Central Fire Station

Town of Hingham ADA Transition Plan

October 2023

Institute for Human Centered Design

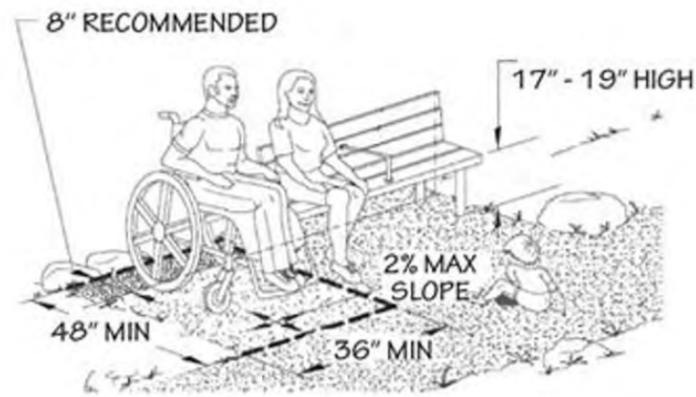
- The senior center parking lot is often full and people must park a great distance away from the building entrance. IHCD recommends providing additional perpendicular or angled accessible parking spaces in the red highlighted area by the senior center shown below in **Figure 2**:

Figure 1 shows a stable, firm and slip-resistant surface adjacent to a bench positioned to allow a person in a wheeled

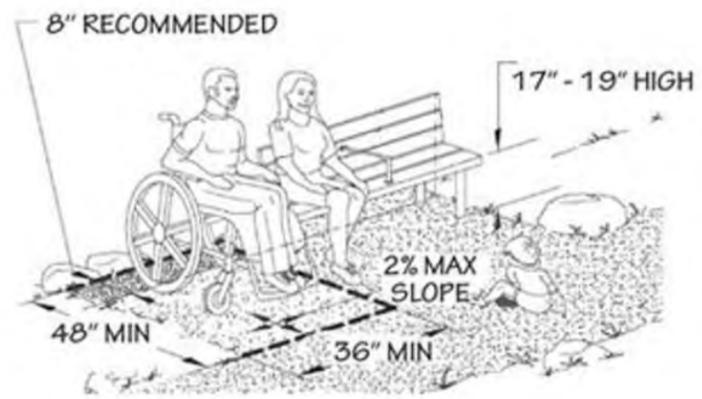
- Recommend providing visually contrasting strips on each stair tread. Recommend providing handrails in a color that contrasts with the wall.
- Recommend providing signage with raised characters and braille on the latch side of the door to all permanent rooms that lack designation signage.
- Recommend relocating the informational signs near the intercom.
- Recommend providing a 36" min. by 48" min. stable, firm and slip-resistant surface adjacent to at least one bench in each exterior area where benches are provided in a manner that is substantially similar to what is shown in Figure 1.

Figure 1 shows a stable, firm and slip-resistant surface adjacent to a bench positioned to allow a person in a wheeled mobility device and a person sitting on the bench to have their shoulders aligned:

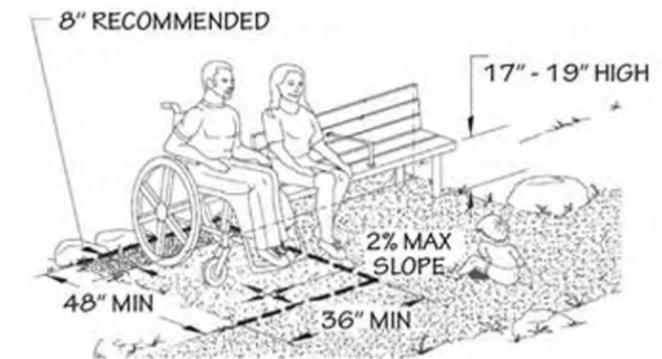
- Recommend providing a 36" min. by 48" min. stable, firm and slip-resistant surface adjacent to at least one bench in a manner that is substantially similar to what is shown in Figure 1.

Figure 1 shows a stable, firm and slip-resistant surface adjacent to a bench positioned to allow a person in a wheeled mobility device and a person sitting on the bench to have their shoulders aligned:

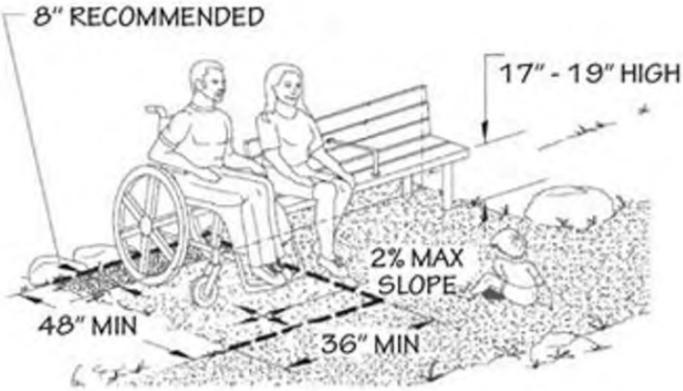
- Recommend providing signage with raised characters and braille on the latch side of the door to all permanent rooms that lack designation signage.
- Recommend providing a 36" min. by 48" min. stable, firm and slip-resistant surface adjacent to at least one bench in the park in a manner that is substantially similar to what is shown in Figure 1.
